Geochemical Consulting Services, LLC

July 28, 2008

I have reviewed documents associated with the Renewal of the Source Material License (No. SUA-1534) for Crow Butte, Nebraska and have found the applicant has not provided sufficient data to demonstrate proper development of (1) baseline water quality in the aquifer exemption zone and (2) excursion limits at monitoring wells.

Figure 1. Chart of aquifer exempt zone (i.e., zone surrounded by monitoring wells) and locations for baseline wells established with valid statistical methods.

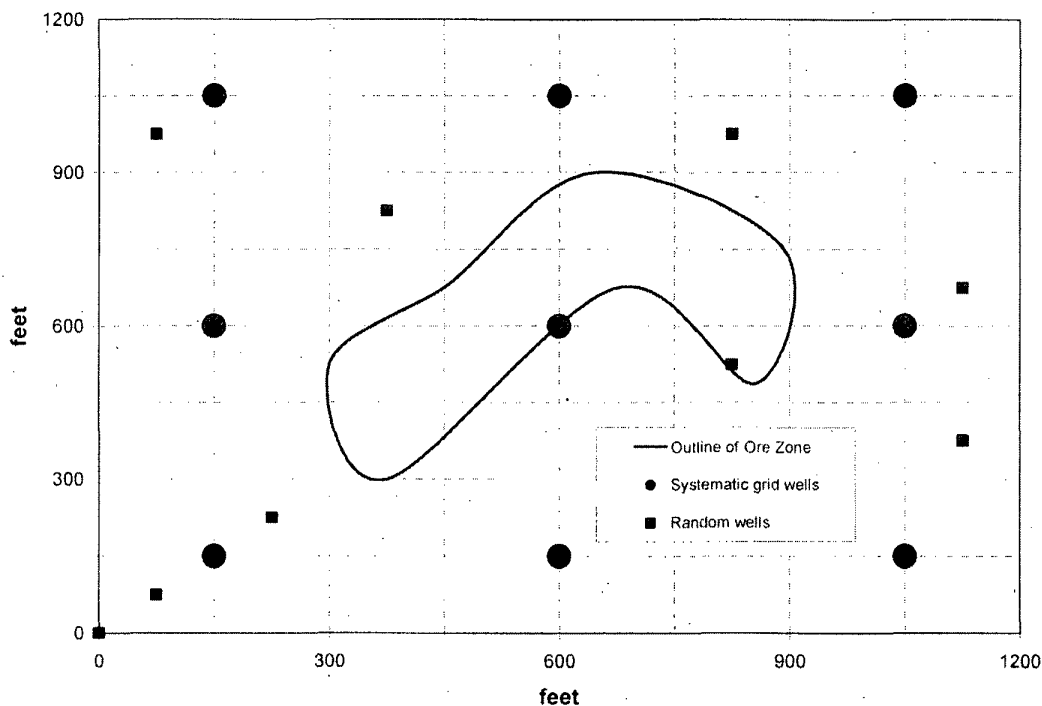
Alternatively, we may elect to locate wells on the grid using a random number generator. In general, less wells are required if they are located randomly, and this is shown on Figure 1 as two random locations per quadrant. Free modeling software, developed by the Pacific Northwest National Laboratory for the Department of Energy (PNNL 2007), allows a large number of scenarios to be evaluated to determine the optimum data quality objectives and sampling approach for the stakeholders.

Assume nine samples were taken from the nine locations on Figure 1 and analyzed for radium-226. A valid statistical sampling of the exempt aquifer zone collects more

Figure 2. Cross section of an aquifer (20 to 90 feet) showing improper (Well 1) and proper (Well 2) sampling intervals to obtain a representative sample.

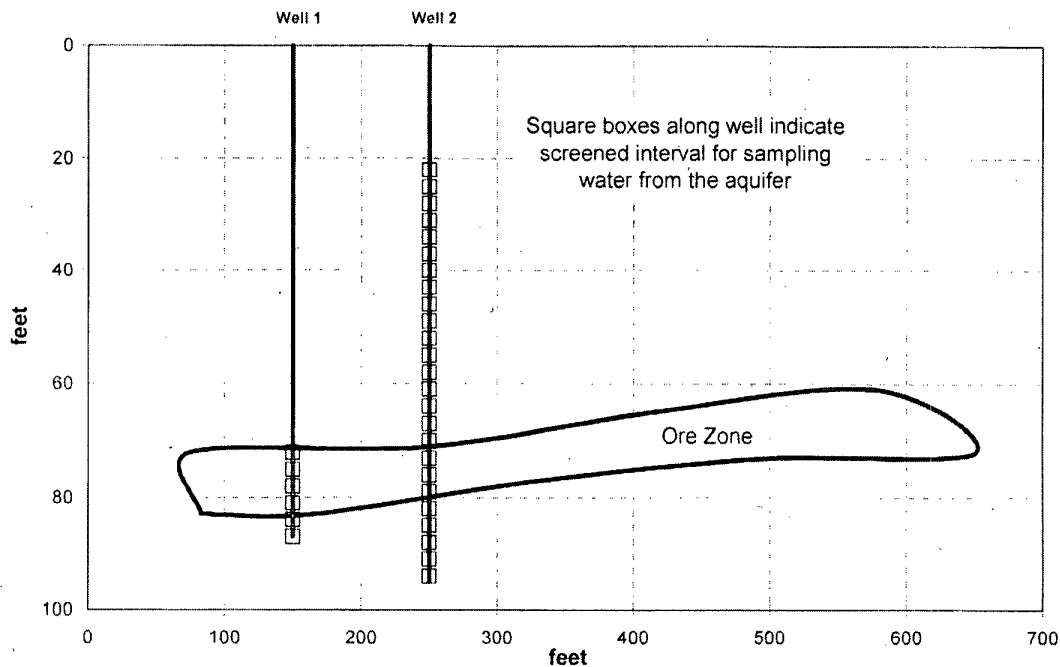
The well logs provided indicate the Chadron is approximately 50 to 80 feet thick through most of the mining area (Figures 2.6-4 through 2.6-11). The sampling interval for the baseline wells is 20 feet (Table 2.9-3), which does not represent the entire thickness of the aquifer. Figure 2 shows that a water sample obtained from Well 1, screened only in the ore zone, returns a biased sample that does not represent the water quality of the column of water at the given location. Well 2 (Figure 2) indicates the correct method for sampling the water, which requires that the entire thickness of the aquifer be screened to obtain a representative sample.

Figure 3. Probability plot indicating that all data do not lie near or on a straight line, which rules out a normal or log normal distribution.

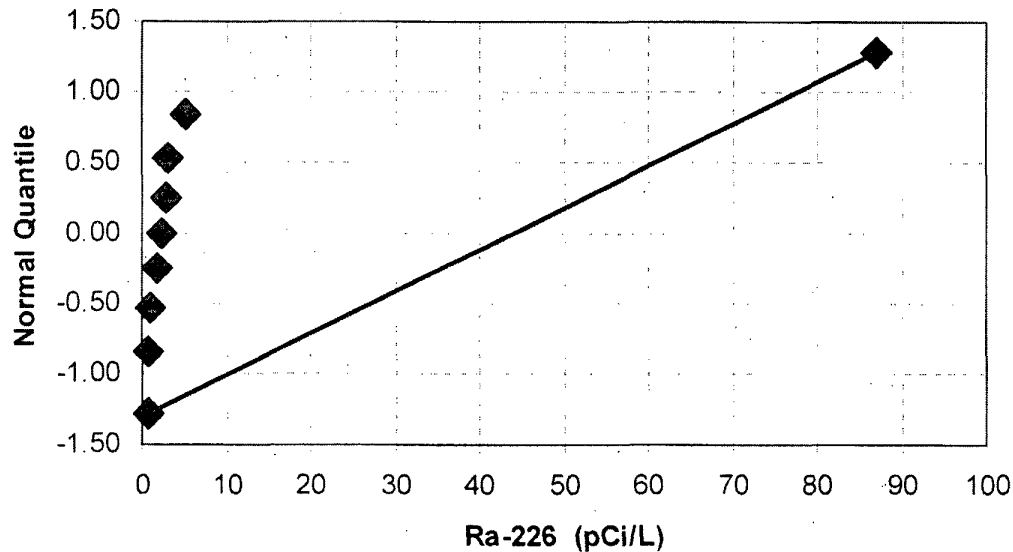
A probability plot of the data (Figure 3) and the results of the Shapiro-Wilk test confirm this. The normal-quantile values must fall on a straight line or the Shapiro-Wilk probability values must exceed 0.05 (at the 95 percent confidence level) for a normal or log normal distribution to be declared, which is clearly not the case. Therefore, the median, and not the mean, must be used to represent the central tendency of the data. Note that inappropriate use of the mean results in a high bias on the estimate of the baseline value for radium-226, which improperly elevates restoration clean-up levels and lowers the costs associated with the number of pore volumes needed to exchange to meet the clean-up levels.

Figure 4. Proper use of a control chart to determine lixiviant excursions.

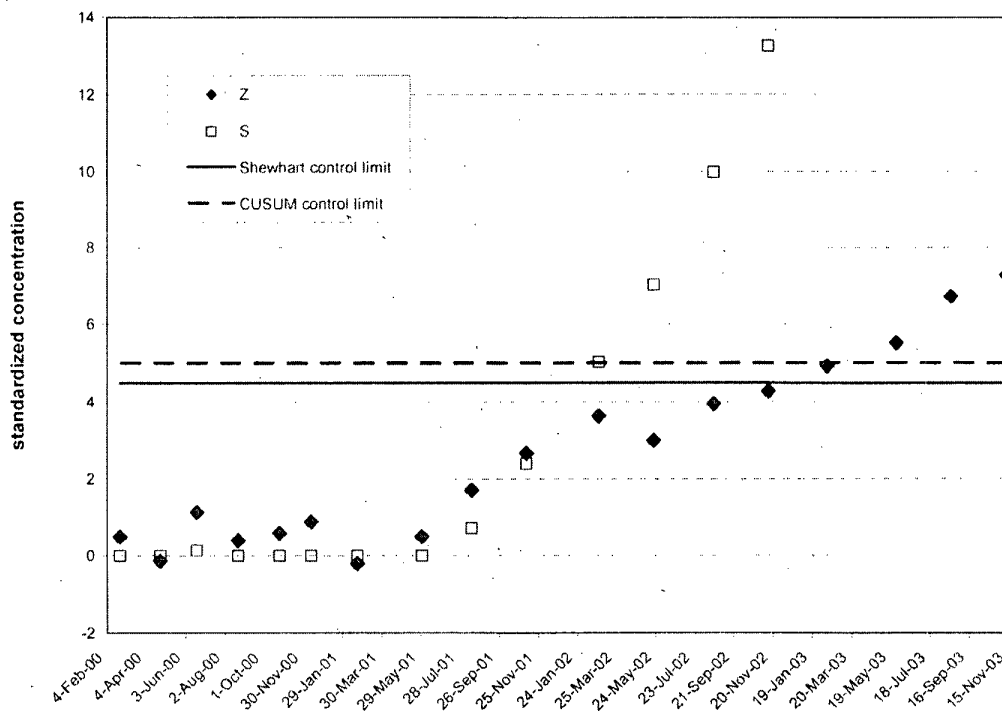
Figure 4 illustrates the importance of using the SCL and CUSUM for monitoring lixiviant excursion. The SCL (Z) and CUSUM (C) are plotted for an excursion parameter, a gradual increase in contamination exceeds the CUSUM limit in February of 2002, while the SCL limit is not exceeded until January of 2003. The SCL limit is similar to the CBR's use of 5 standard deviations above the mean for any one sampling event, although EPA recommends 4.5 standard deviations for any one sampling event. Using only the SCL limit allows contamination to migrate beyond the monitoring well for nearly a year before an excursion is declared. Therefore, if the CUSUM is not used with the SCL limit a gradual increase in contamination will not be detected and migration of diluted lixiviant will pass the monitoring well without corrective action.
